**PROJECT NUMBER / TITLE: PP-20-02: Preliminary plat for Frontier Commerce Park 1<sup>st</sup> Plat**

**Type of Request:** Preliminary Plat  
**Date Received:** January 10, 2020

The applicant requests approval of a preliminary plat for a 2 lot commercial project containing 3.24 acres.

**PROJECT NUMBER / TITLE: SP-20-01: Site Plan Review for Frontier Community Credit Union**

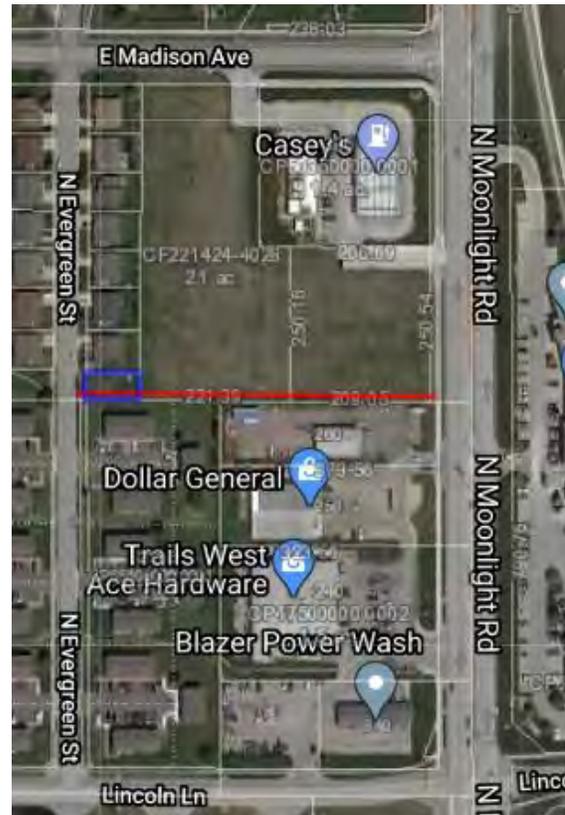
- *The LDC provides for exceptions to block and connectivity standards. In this case, the block length is slightly over the maximum of 1,000 ft and substantially over the maximum block area of 8 acres. When exceptions for larger blocks apply, the Planning Commission may require pedestrian walkways through blocks. Additionally, the LDC provides that development sites shall include direct sidewalk connections in the most direct manner with adjacent sites where pedestrian connections through public streetscapes or internal access is remote (there are no sidewalks along the existing or proposed access drive). Sidewalk connectivity is needed to the vacant lot to the west as shown on the photo at right. The applicant has, consistent with Staff request, provided for a public access easement containing a 5' sidewalk along the south property boundary of this lot and the adjacent vacant lot. The City will need to pursue the remaining sidewalk connection across the drainage easement (tract outlined in blue) for the adjacent subdivision Madison Park to connect with Evergreen Street (approximate sidewalk location shown in red).*

**1 west elevation**  
3/8" = 1'-0"

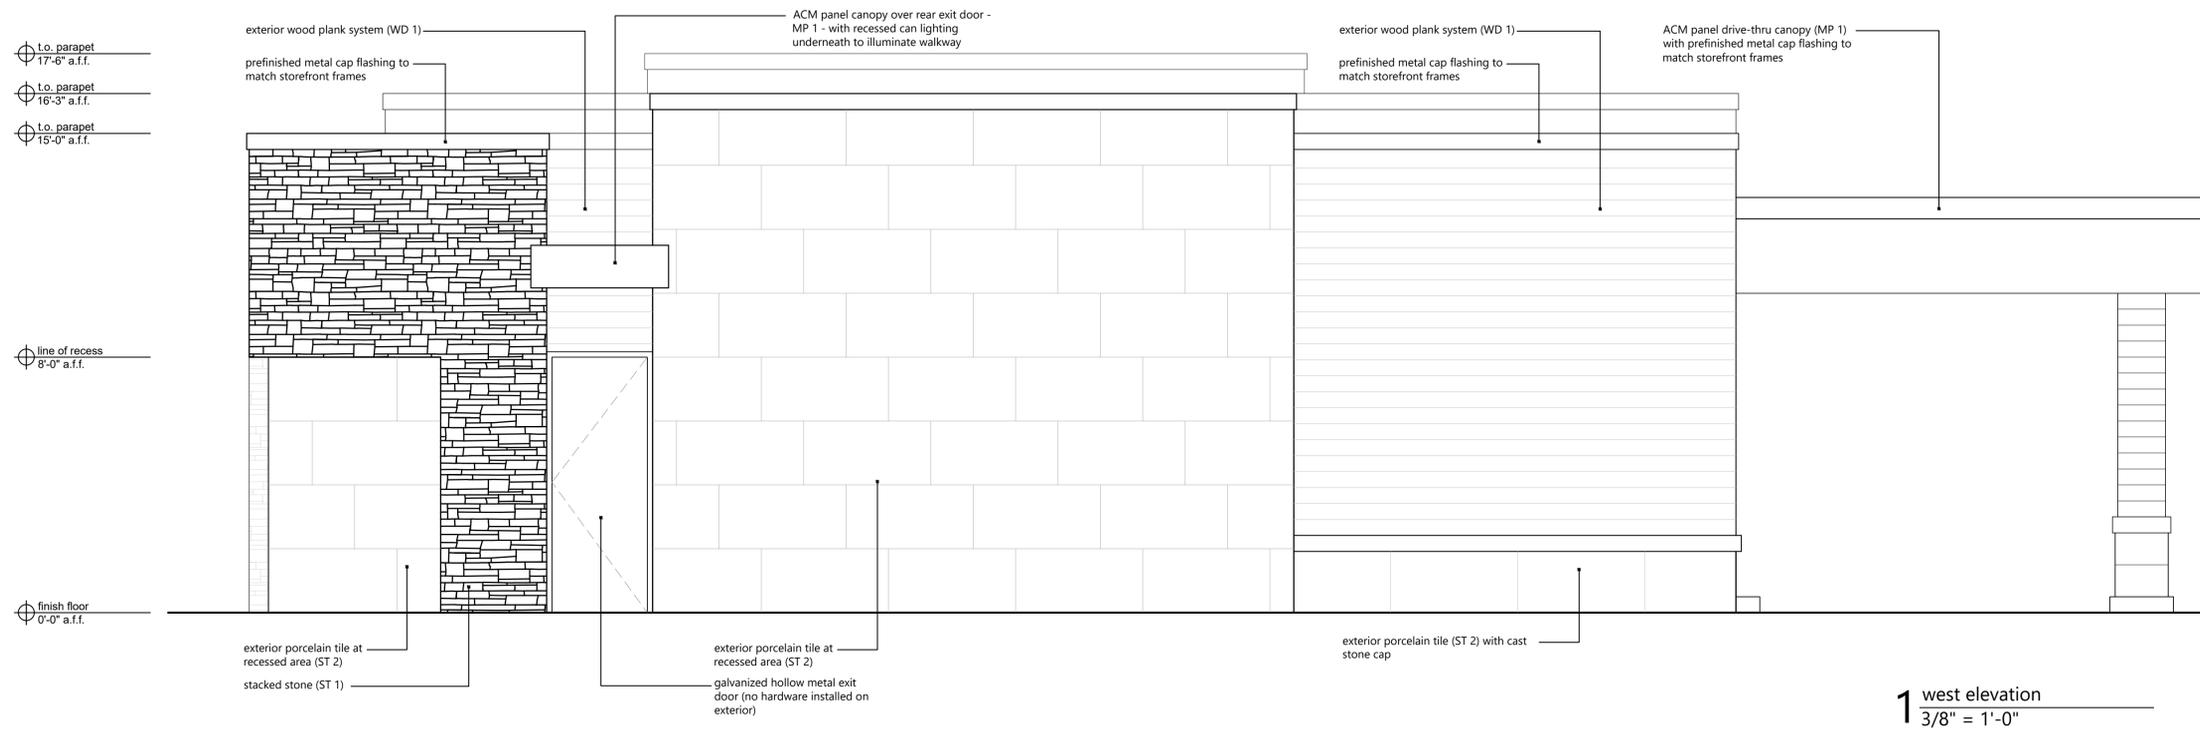
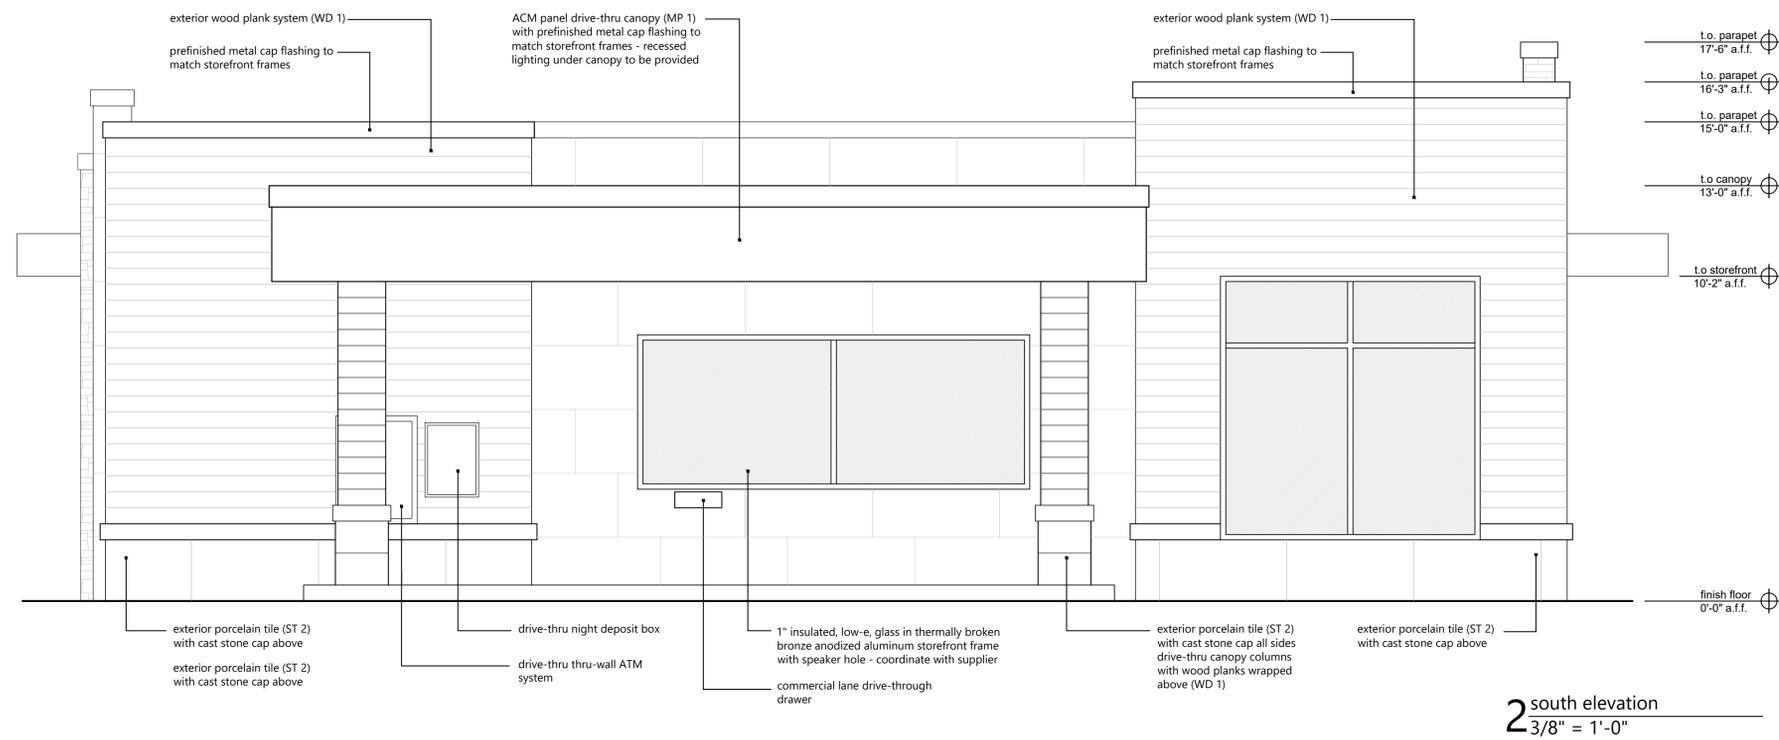
**Staff Comment:** *As discussed previously, a recommended condition of approval addresses screening of the rooftop mechanical equipment.*

5. Provide a maintenance agreement for the shared access easements prior to the release of the plat for recording.
6. If the rooftop mechanical equipment is not adequately screened by the building parapets, the equipment will be screened in accordance with Sections 17.05.020 (B.1) and 17.08.040 (A.1).
